UNITED STATES PATENT AND TRADEMARK OFFICE

Office Action Summary	Application No. 10/723,644	Applicant(s) JANG, G. DAVID	
	Examiner Vy Q. Bui	Art Unit 3773

DETAILED ACTION

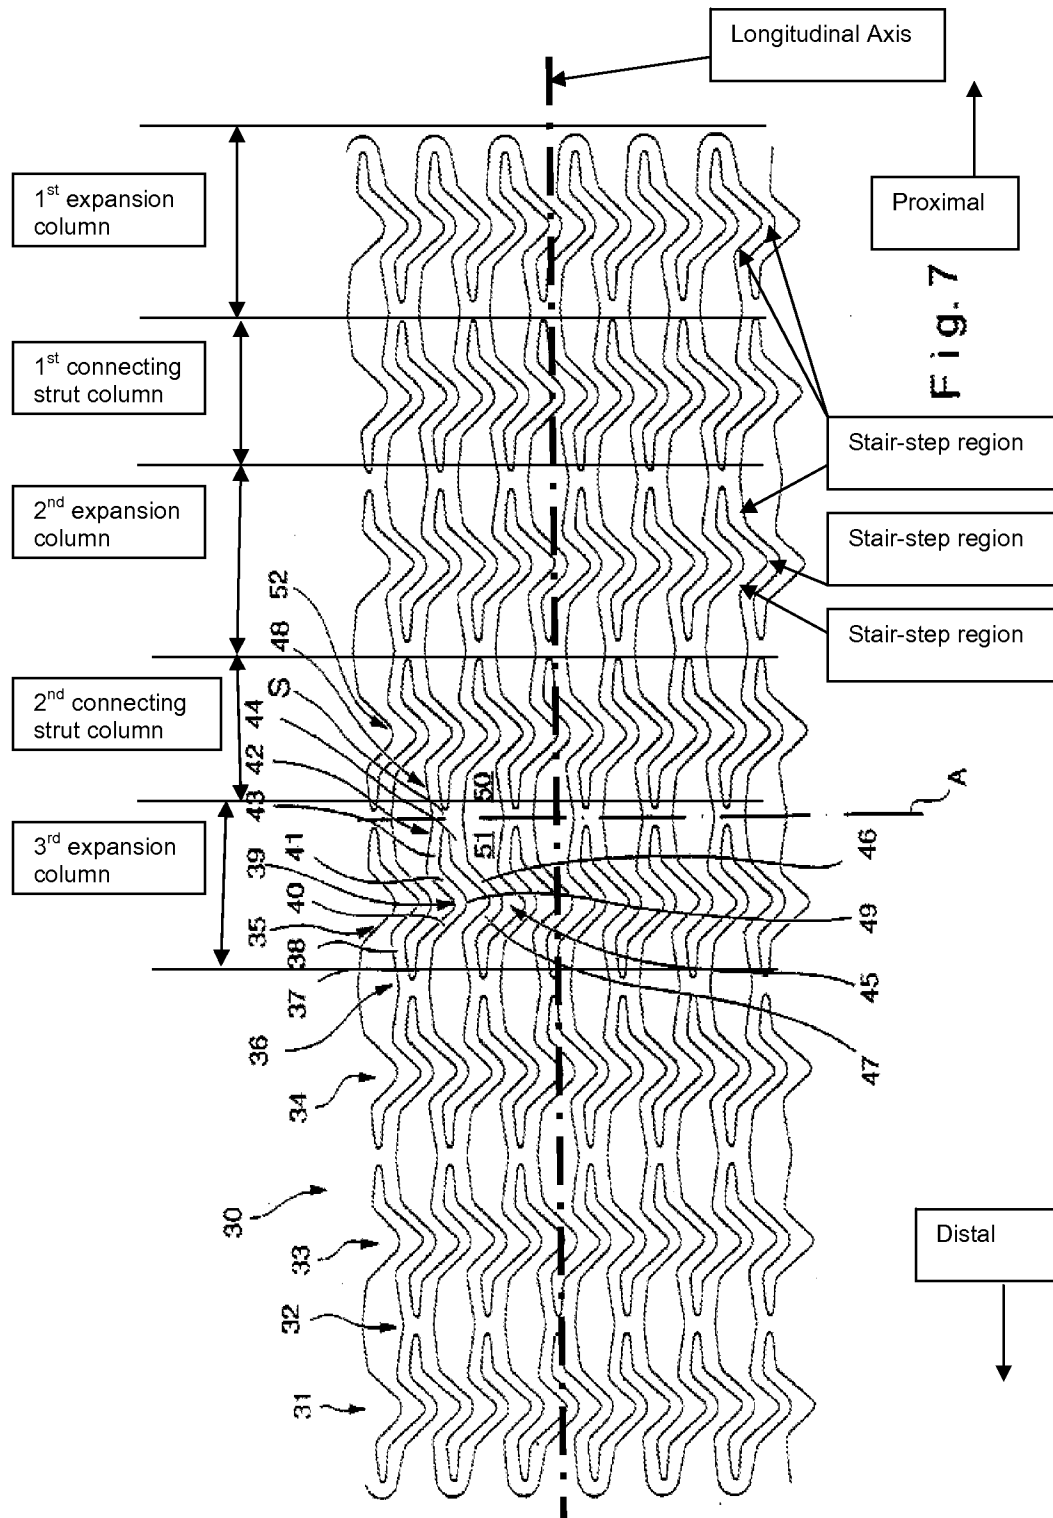
Claims 1-9, 10, 12-23 are rejected under 35 U.S.C. 102(e) as being anticipated by WO98/35634 or US 6,193,747 B1.

As to claims 1-9, 10, 12-23, Fig. 7 of WO98/35634 or US 6,193,747 B1 as shown below includes substantially all structural limitations, such as stair steps, 1st, 2nd, 3rd expansion columns, 1st and 2nd connecting strut column, of the claimed invention:

Fig. 7 of WO98/35634 or US 6,193,747 B1 does not disclose a strain relief notch. However, Fig. 8 of WO98/35634 or US 6,193,747 B1 shows strain relief notch 72, 74, for example. It would have been obvious to one of ordinary skill in the art to form strain relief notches to the stent shown in Fig. 7 of WO98/35634 or US 6,193,747 B1 as disclosed in Fig. 8 of WO98/35634 or US 6,193,747 B1 as this configuration provide a strain relief region for the stent.

A fair reading of Von Oepen reference and Fig. 7 as shown in the previous non-final office action would clearly reveal that, like all other stents in the art, the Von Oepen stent has a longitudinal axis, proximal and distal directions. Regarding stair-step regions, from Fig. 1 (elected species) and the specification of the present invention, it is clear that any bend or sudden change in the strut, such as locations labeled as 39 with straight legs 40, 41 (Von Oepen's Fig. 7), is recognized as a stair step region. The annotated Fig. 7 of Von Oepen in the non-final previous "Office Action" was self-explanatory and at least sufficiently clear to convey the position of the examiner.

It is confirmed that by identification of 1st, 2nd and 3rd expansion columns, 1st and 2nd connecting columns in Von Oepen's Fig. 7, the other elements such as proximal, distal directions and stair-step regions are clearly recognized by any one of ordinary skill in the art, especially the applicant, who is very skillful in the art.

The amendment filed on 10/21/2008 under 37 CFR 1.131 has been considered but is ineffective to overcome the Von Oepen reference. Von Oepen's Fig. 7 as shown above clearly show 1st and 2nd expansion strut pairs similar to a strut pair in 3rd expansion column shown as strut pair having bend/loop 39 with straight legs 40, 41 and bend/loop 45 with straight legs 46, 46.

These strut pairs of 1st, 2nd and 3rd expansion columns in Von Oepen's Fig. 7 clearly show step regions similar to step regions as specified in Fig. 1 and specification of the present invention.
